**TOWNSHIP OF NORTH DUMFRIES  
BUILDING DEPARTMENT**

These Plans have been examined for Compliance with the Ontario Building Code requirements. A Building Permit has been Issued, subject to any changes noted, under the condition that the building will be constructed in accordance with the code.

Tice River Homes  
Legacy

client: Tice River Homes  
location: Ayr  
project: Legacy  
marketing name: Legacy

FRONT ELEVATION ELEV 'A' (LEFT)

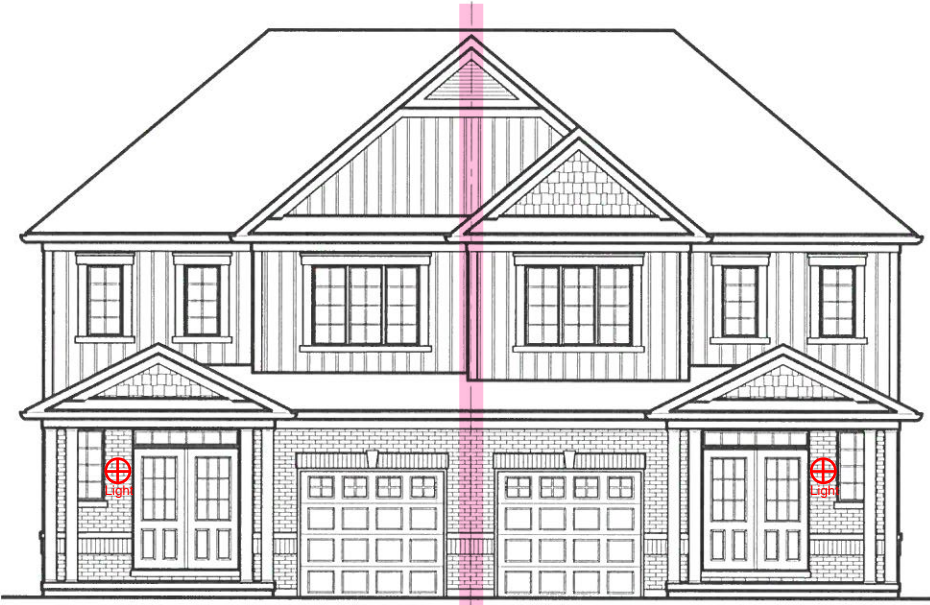
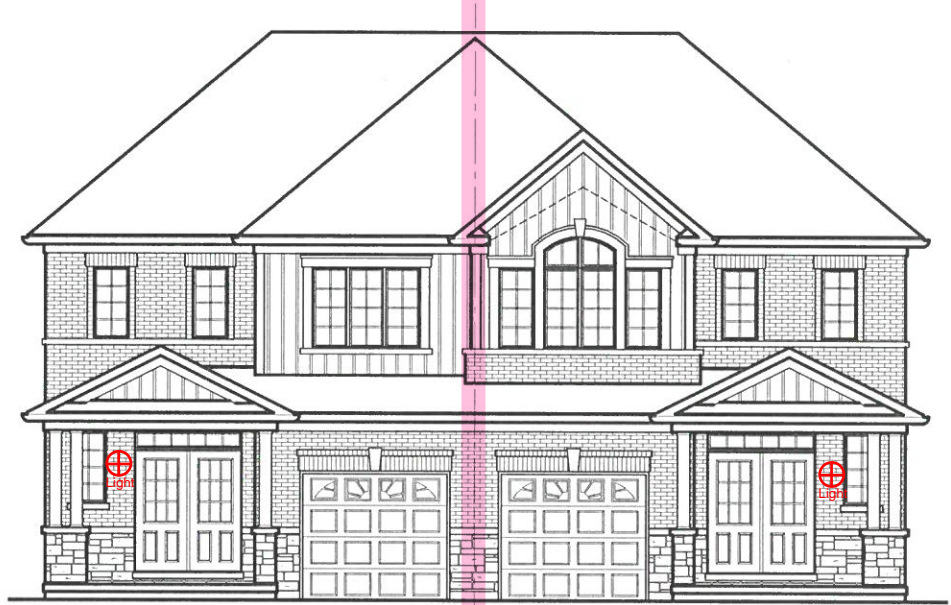
APPROVED DRAWINGS HAVE BEEN RED LINED INDICATING A CHANGE TO MEET THE OBC. PLEASE REVIEW ALL PAGES TO ENSURE YOU ARE PROPERLY INFORMED OF CHANGES.

**= A CONTINUOUS FIRE SEPARATION WITH 1 HOUR FIRE RESISTANCE RATING AND MINIMUM 50 SOUND TRANSMISSION CLASS RATING REQUIRED.**

**BASMENT FLOOR PLAN  
ELEV. 'A' & 'B'(LEFT)**

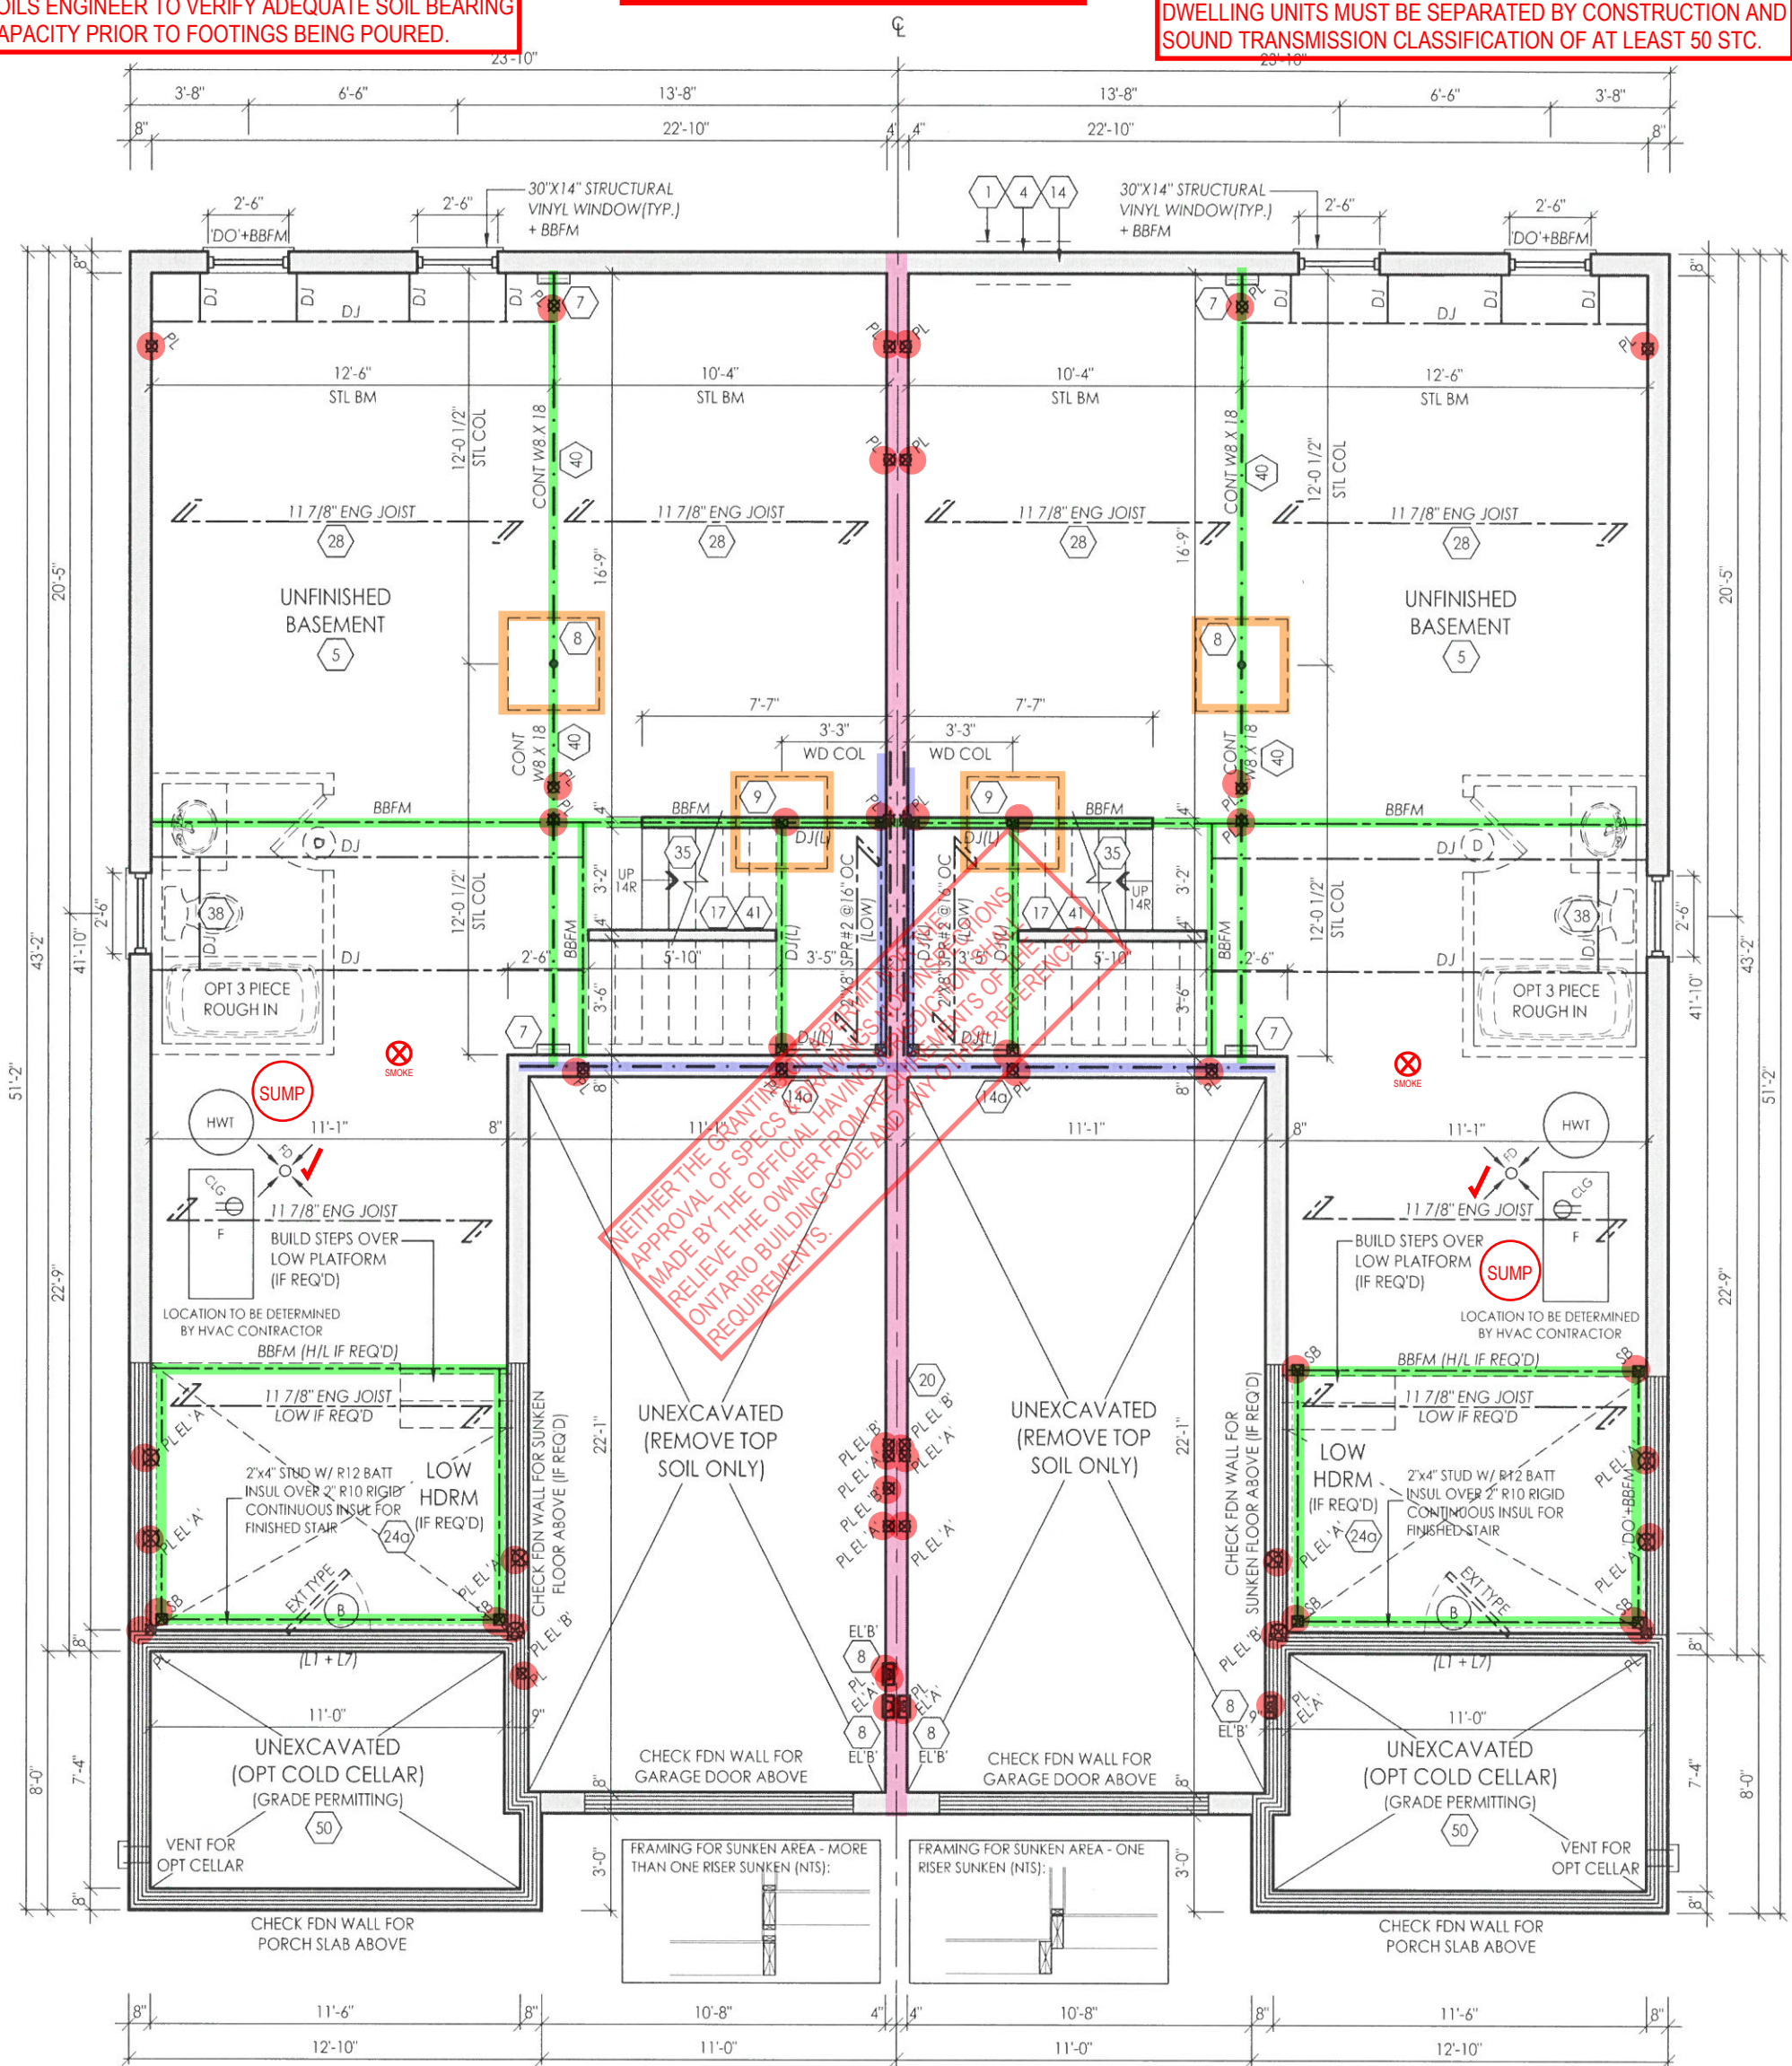
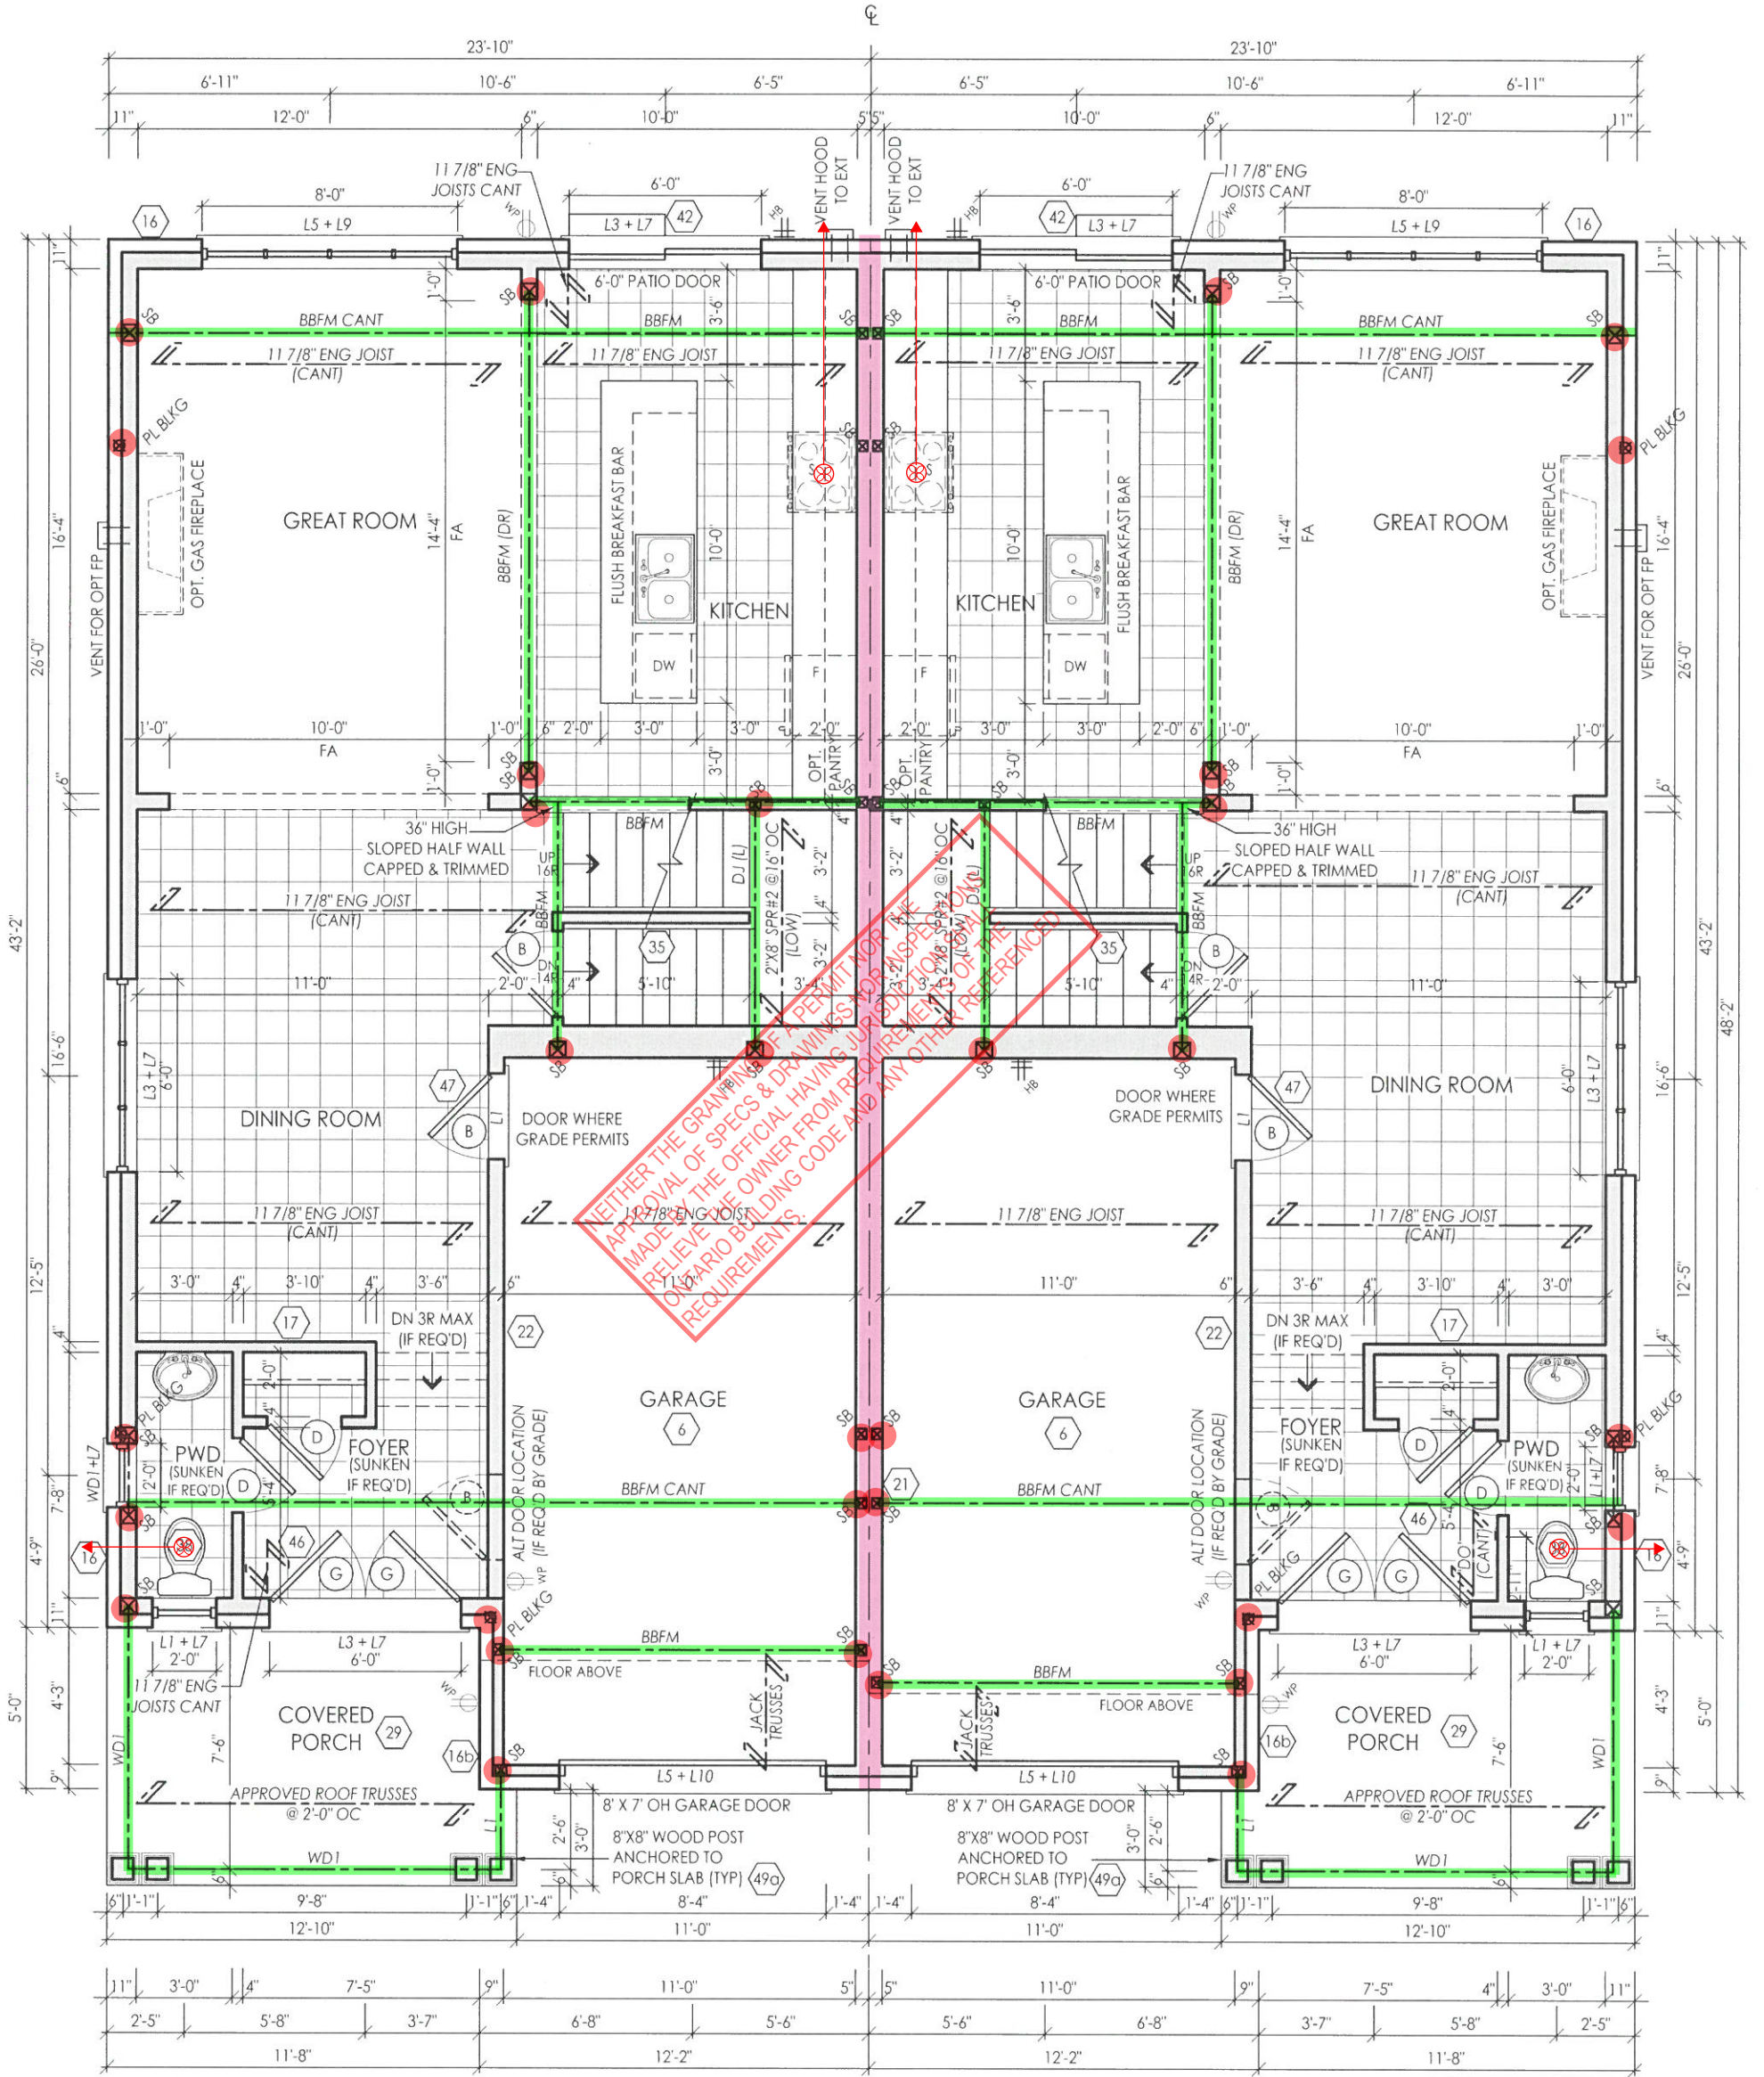
**A FOUNDATION REBAR INSPECTION MUST BE PERFORMED PRIOR TO POURING FOUNDATION WALLS.**

**SOILS ENGINEER TO VERIFY ADEQUATE SOIL BEARING  
CAPACITY PRIOR TO FOOTINGS BEING POURED.**

**DWELLING UNITS MUST BE SEPARATED BY CONSTRUCTION AND  
SOUND TRANSMISSION CLASSIFICATION OF AT LEAST 50 STC.**

**THE COLD CELLAR DOOR NEEDS TO BE INSULATED AND WEATHER-STRIPPED.**

**SUMP PUMP/PIT SHALL BE INSTALLED AND CONNECTED ACCORDING TO LOCAL REGULATIONS.**
